Re: Site Plan Application Review Follow-Up
Map 7, Lot 39 and 39-1
Warner, New Hampshire

On behalf of the Town of Warner (Town) Planning Board, Aries Engineering, LLC (Aries) prepared this follow-up to our discussions at the November 3, 2025, Planning Board meeting where we discussed the Site Plan application prepared by Keach-Nordstrom Associates, Inc. (KNA) of Bedford, New Hampshire for the property identified as Lots 39 and 39-1 on Warner Tax Map 7 (site) in Warner, New Hampshire.

The objective of this letter is to demonstrate that the stormwater drainage system proposed by the applicant will substantially increase both off-site stormwater flow volumes and velocities onto the northerly abutting property. Attached Figure 1 depicts outlines of the pre-development and post-development areas modeled as part of this study.

FIGURE 1

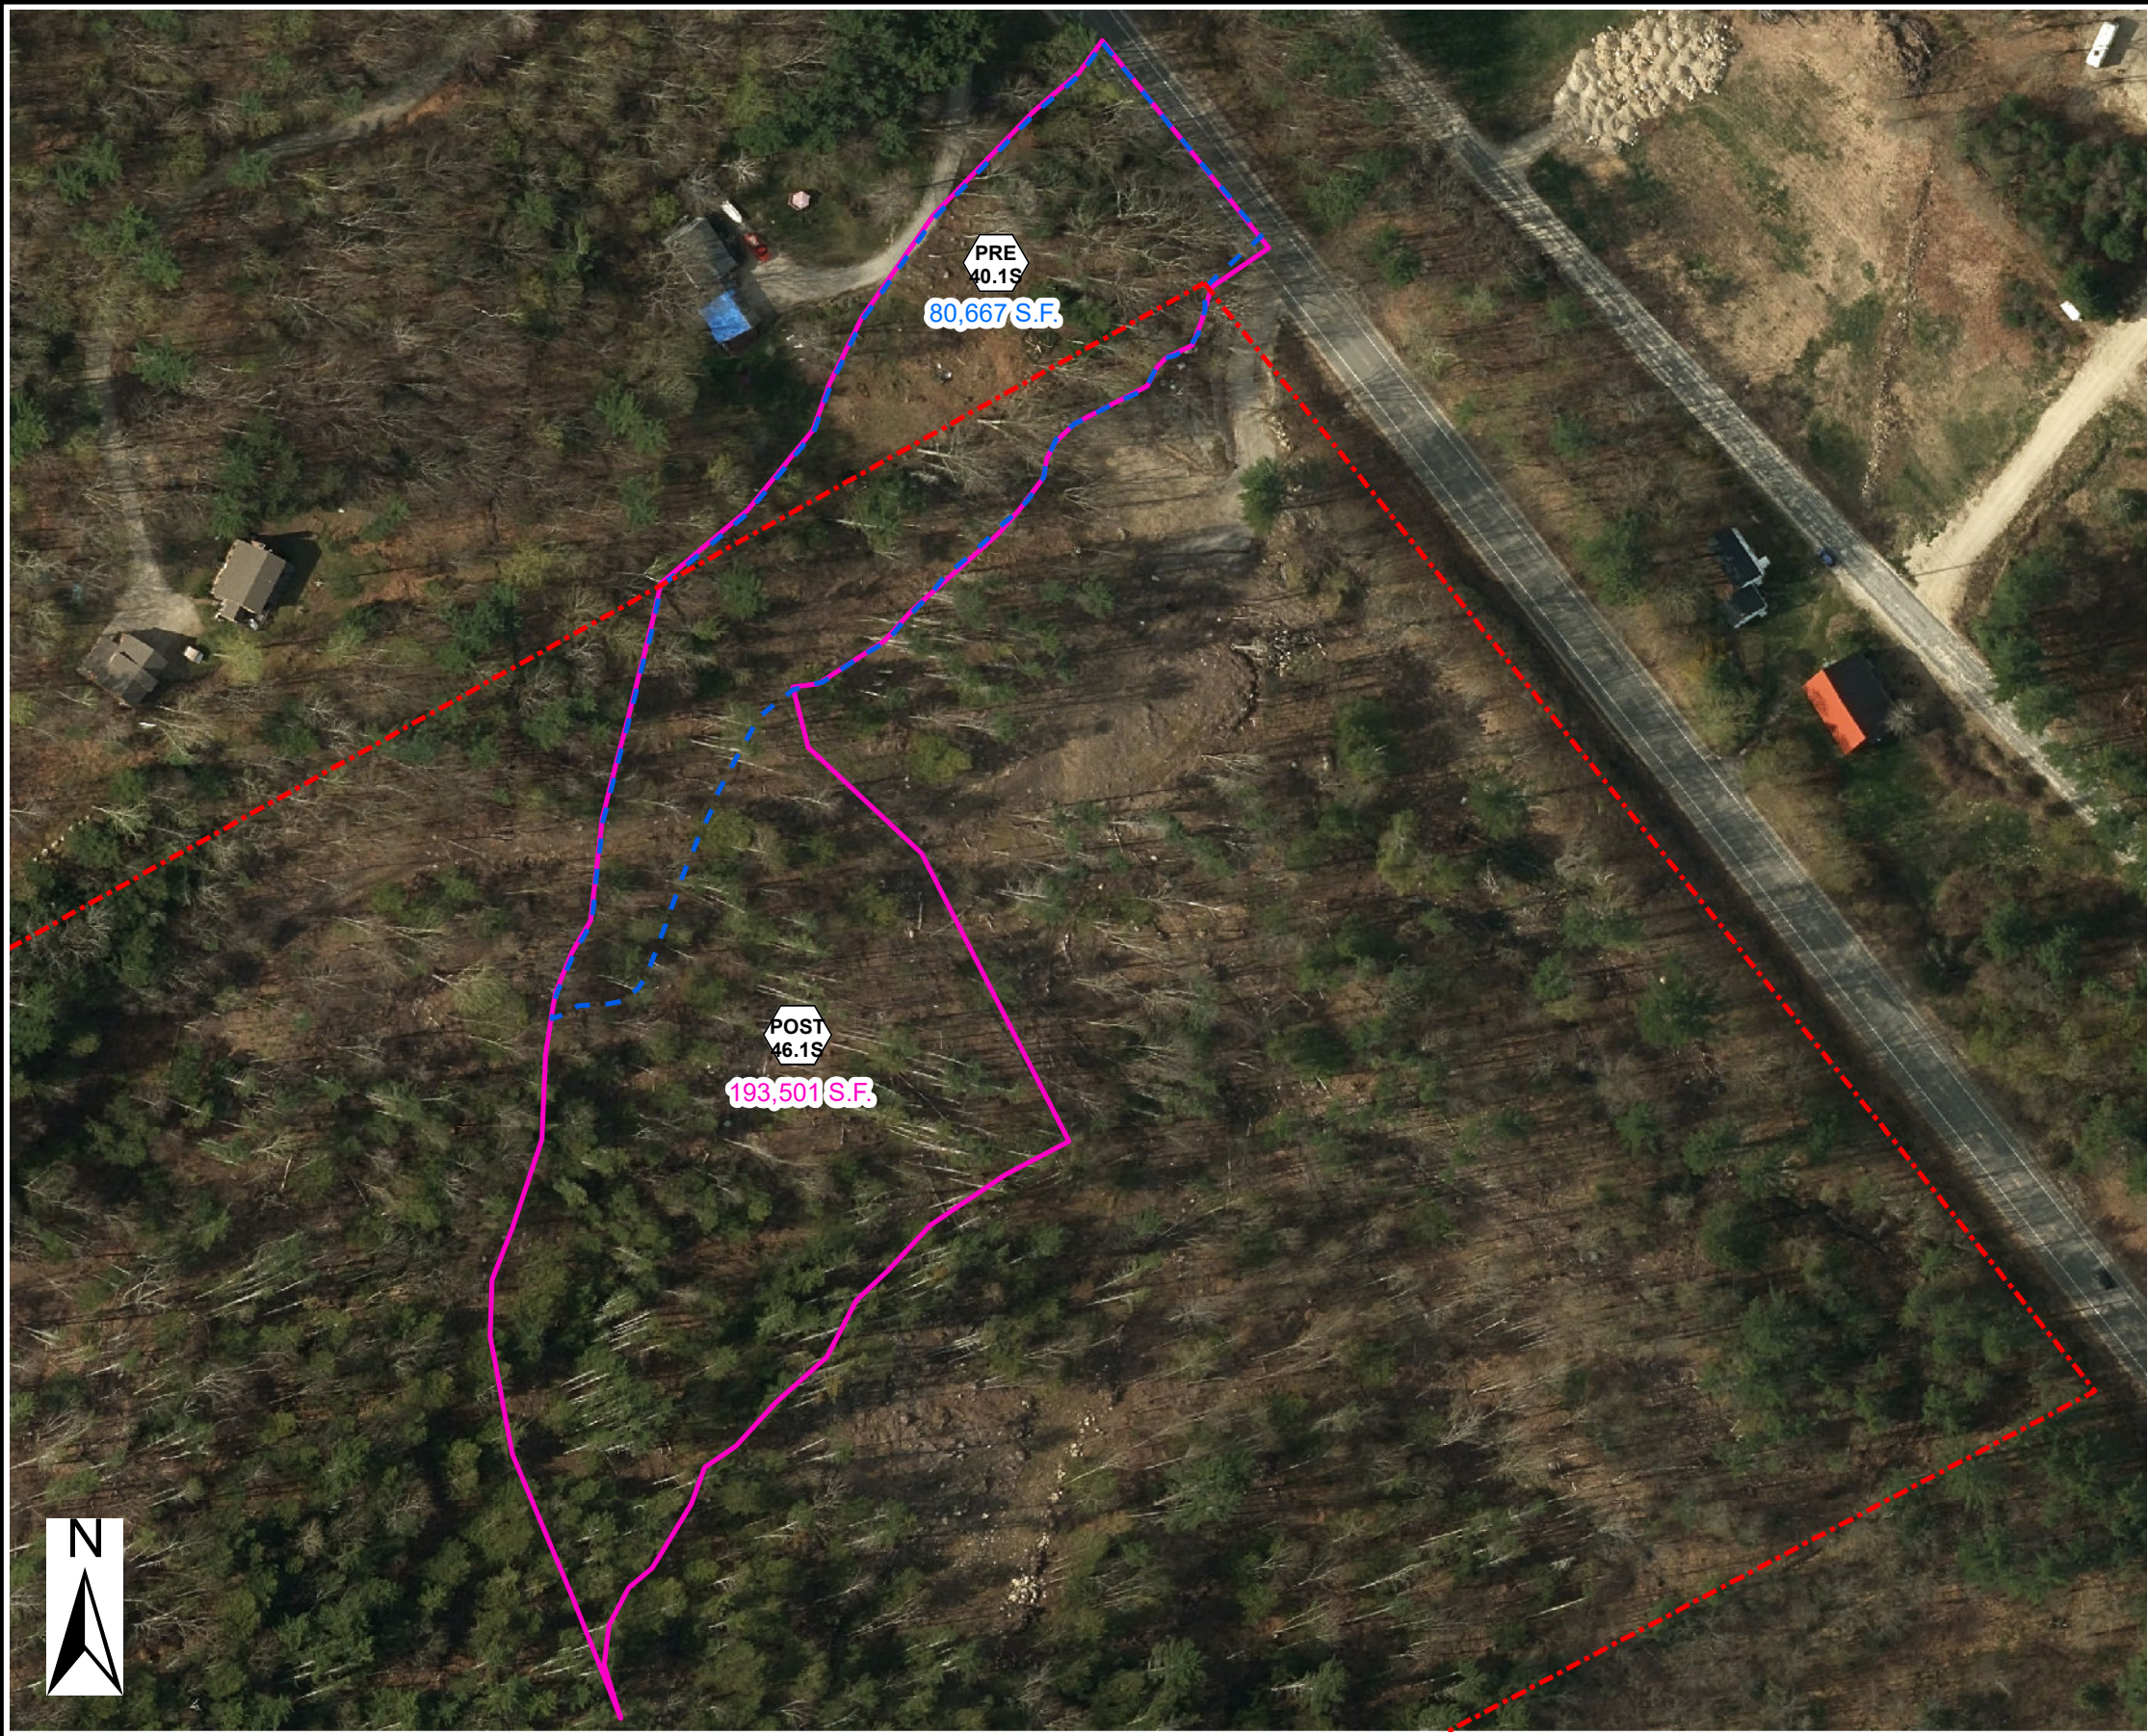
The pre-development drainage area, identified as subcatchment 40.1S, is depicted on Figure 2 and covers an approximate 80,667-square-foot (sf) area, while the approximate 193,501-sf post-development drainage area, identified as subcatchment 46.1S, is depicted on Figure 3. As noted during the November 3, 2025, meeting, Figure 3 depicts a drainage swale at an approximate elevation starting at 506 feet that captures surface water from the upper portion of Lot 39 and directs this stormwater to a level spreader that is located near the northerly boundary of Lot 39. The presence of the drainage swale increases the area of contribution to the off-site stormwater flows by a factor of approximately 2.4. As discussed at the meeting, this significant increase in area capturing rainfall during storm events is the primary reason for the increased off-site stormwater flows.

Aries recommends that the stormwater drainage from upslope drainage swales be directed to a stormwater management practice located at distance from the northerly site property boundary to limit concentrated stormwater flows toward the northerly abutting property and to reduce the off-site post-development stormwater flows to be less than the pre-development peak rate and volume.
